Revisions and Errata List
AISC Design Guide 1, 3rd edition, 1st Printing (Printed Edition)
May 23, 2025

The following list represents corrections to the first printing of AISC Design Guide 1, 3rd edition, *Base Connection Design for Steel Structures*.

Fig. 4-24. Base connection section for configuration used in Example 4.7-4.

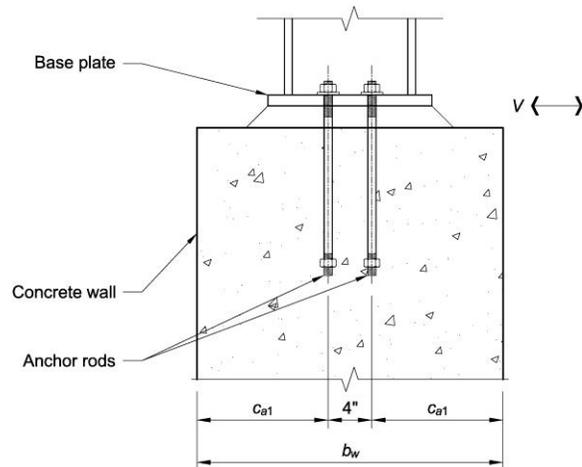
77 Figure 4-24 should be revised to:

Fig. 4-28. Base connection as detailed in Example 4.7-7.

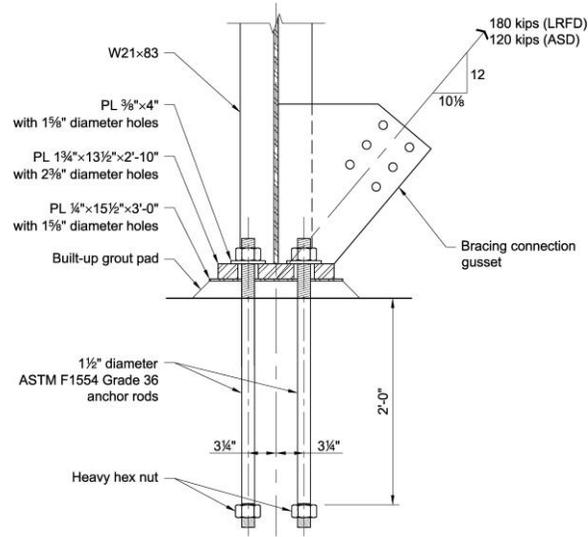
Figure 4-28 should be revised to:

Fig. 4-30. Base connection elevation view detailed in Example 4.7-8.

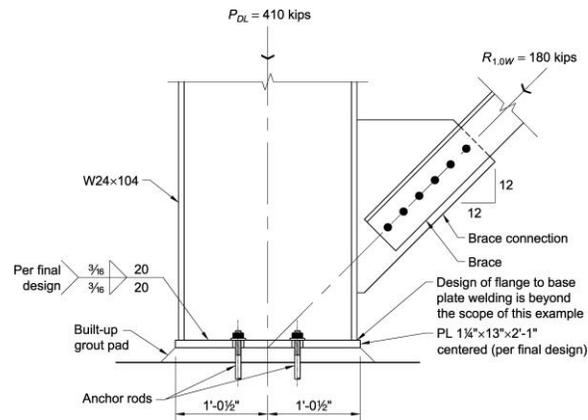
Figure 4-30 should be revised to:

(a) Overview

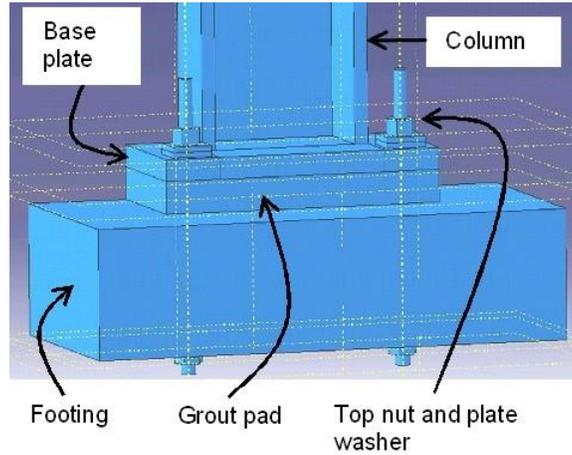
Figure D-2(a) should be revised to:
